# Draft Submission to the Roads and Maritime Services Preferred Option for the Batemans Bay Bridge

1 September 2017

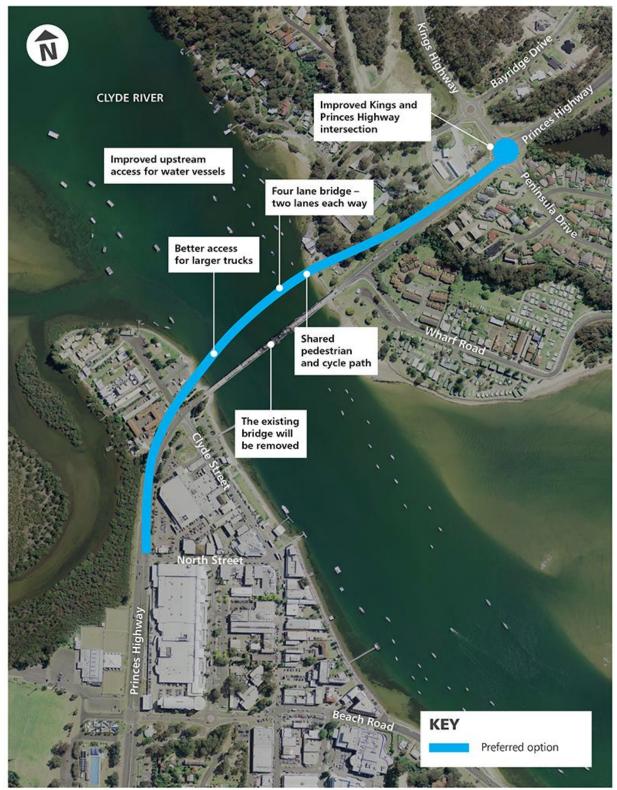
- a. Consolidate access and future works expenditure to the sections of Wharf Road that are not at risk from erosion
- b. Allow the existing connection to Peninsula Drive to erode and rely on the lower maintenance access from the Princes Highway
- c. Consolidate future development behind areas that are protected by existing rock walls.

Closing the Princes Highway access will restrict management of the hazard to maintaining the Peninsula Drive access. This will represent a significant cost to Council as the works will need to mitigate against coastal erosion and coastal inundation over the design life of the asset and beyond. Works would need to include:

- Design and construct 450 to 500m section of rock wall to design life that meets sea level rise projections beyond 2100
- b. Back fill corresponding section of rock wall
- c. Design and construct section of Wharf Road to new landform alignment
- d. Remove, relocate and replace associated services behind new works.

This substantial cost cannot be met by Council within the planning and construction period of the new Clyde River bridge crossing. RMS should take some responsibility for investment in this area to address this critical environmental hot-spot and/or engage with the NSW Government to secure funding for the necessary works to secure the Wharf Road access back to Peninsula Drive.
